Bradley Hills Grove, Pre-Preliminary Plan 720110110

Staff Report Date: 1/6/12

description

6817 HILLMEAD ROAD
 PROPOSED LOTS 42, & 43,
 BRADLEY HILLS GROVE, BLOCK B
 NEIGHBORHOOD MAP

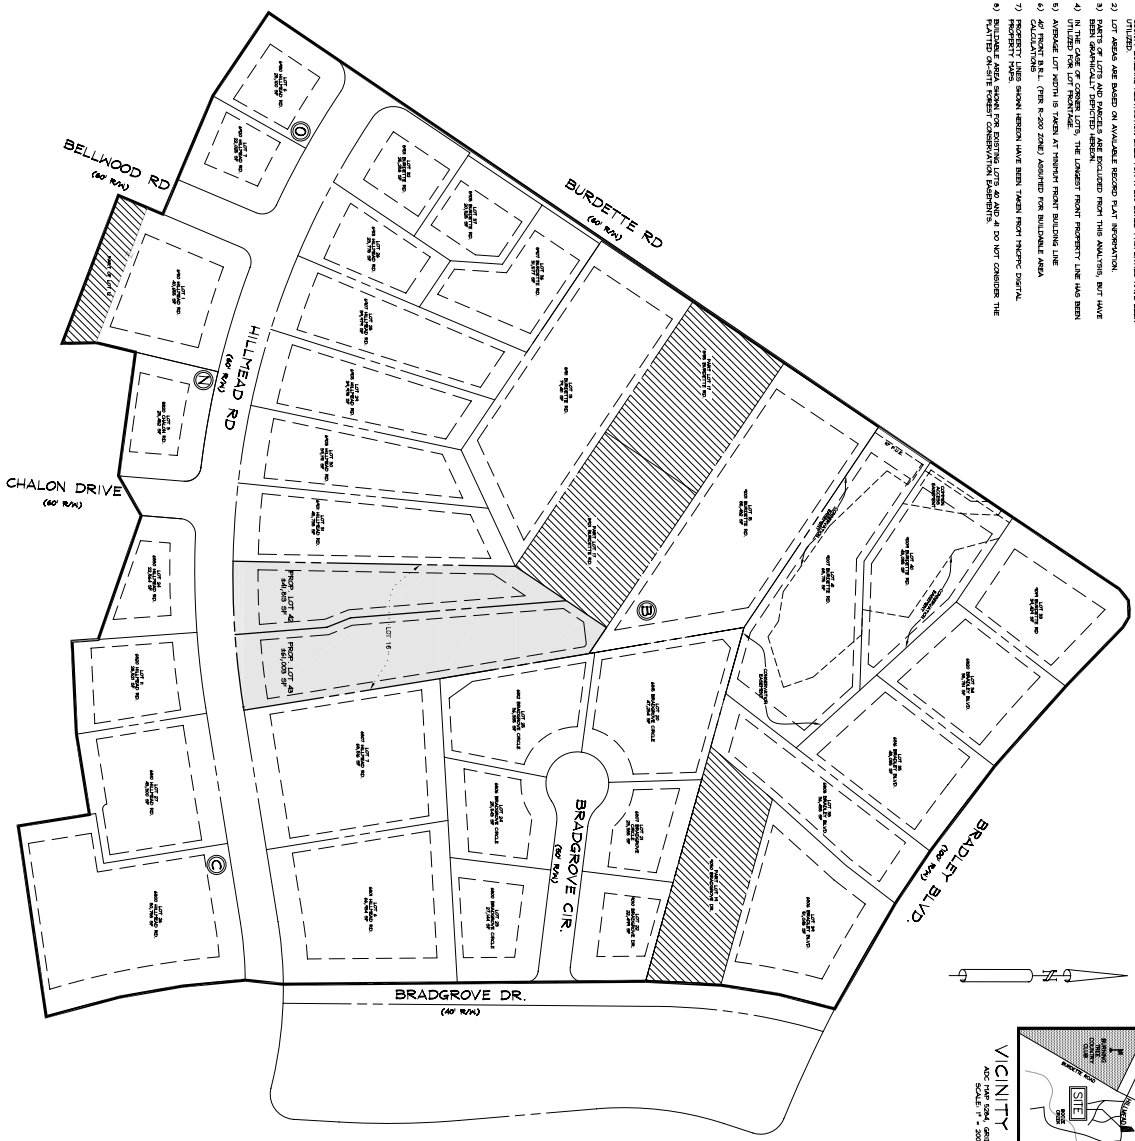
To analyze existing and proposed lots, a resubdivision "Neighborhood" must be delineated. The applicant has submitted a map for evaluation in determining the appropriate "neighborhood" for this application. In this instance, the Neighborhood selected by the applicant consists of 33 lots. (Attachment C). The neighborhood includes lots on Hillmead Road, Bradley Boulevard, Bradgrove Circle, Burdette Road, and Bradgrove Drive. All the lots share multiple access points on those streets. Staff agrees with the applicant's neighborhood delineation.
